Downtown Carpark Site Development

FTAA-2512-1158
BUN60460864, LUC60460865, DIS60460866 and WAT60460867

2.0 Technical Specialist Memo – Urban Design

Figure 1. The extent of the proposed HEHCP infringements of T1 compared against a tower of a similar height (in red) that complies with other controls in this location.

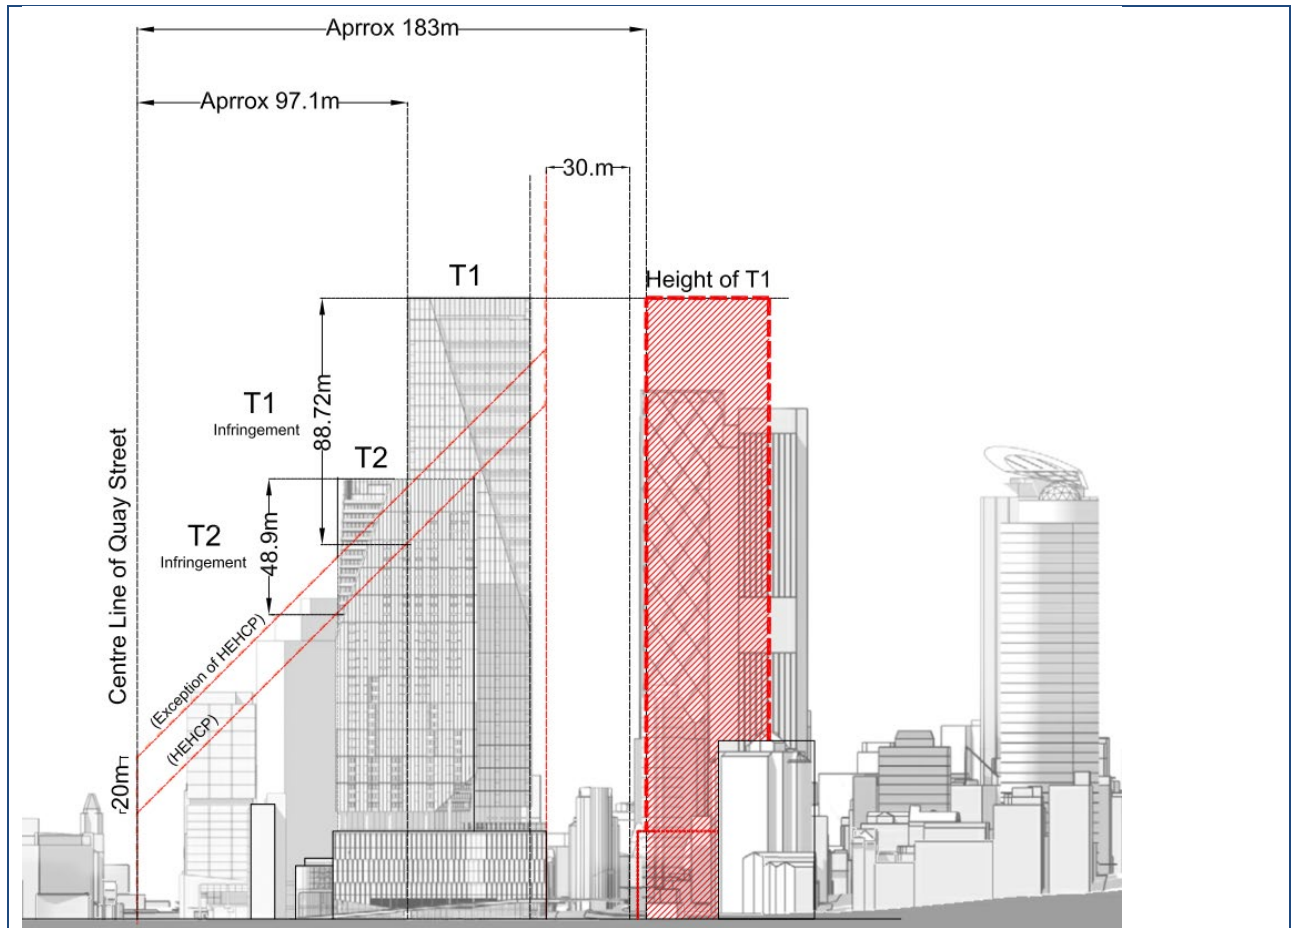
Figure 1 (attached below) from my original R.C assessment illustrates this relationship in form-based terms. Under the wider built form expectations of the City Centre zone, a tower of similar height to Tower 1 could potentially be achieved in the next block to the south, beyond Customs Street West, at approximately 180m from the centre line of Quay Street. By comparison, the proposed Tower 1 is located approximately 97m from the centre line of Quay Street. This narrows the intended transition

band by approximately 50% and brings a tower of this scale approximately 86m closer to the waterfront than anticipated. In practical terms, this removes a step in the intended height transition south of Customs Street West and results in a more abrupt escalation of built form toward the harbour edge.

- The proposal achieves a degree of transition through the placement of taller built form to the south and lower built form to the north.
- However, the transition is materially compressed relative to that anticipated by the Harbour Edge Height Control Plane.

- The proposal brings substantial height and associated bulk closer to the waterfront than envisaged by the AUP, effectively introducing a tower of this scale approximately one block closer to the harbour edge.

- This results in a departure from the planned built form transition for this part of the city centre.
- While the podium levels will define much of the immediate street experience, the upper-level massing remains relevant in terms of the proposal's relationship to the waterfront edge and the wider transition in urban form.
